9 April 2021

Proposed Mini-Roundabout, junction of A3026 and Court Lane

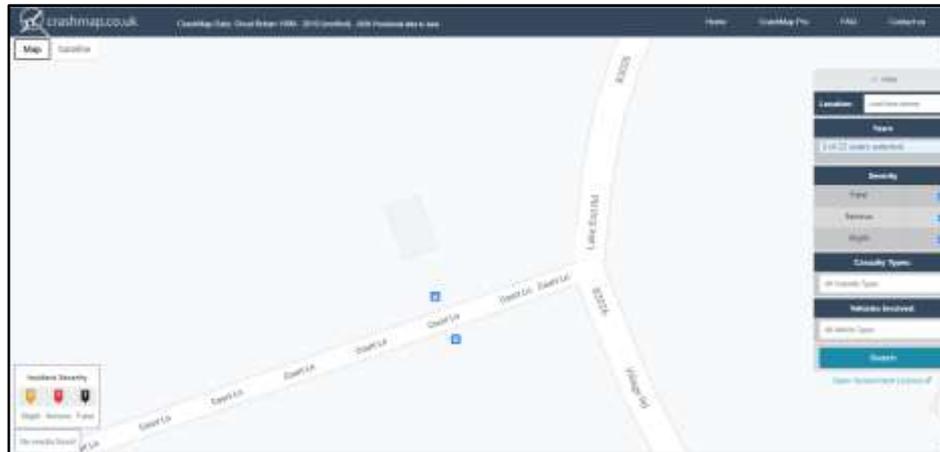
As a starting point, in accordance with the Government's planning practice guidance, I have reviewed the last three years' road collision data prior to the change in priority at the junction (this is the years 2017, 2018 and 2019). The extract below from the Crashmap database shows that there were no recorded collisions at the junction during this three-year period.

This suggests to me that historic arrangement with the priority movement being the A3026 North – A3026 South with Court Lane forming the minor arm combined with a right turn lane provided on the A3026 for traffic turning right from the A3026 North into Court Lane, was safe and suitable for the volume, type and pattern of vehicle movements at the junction.
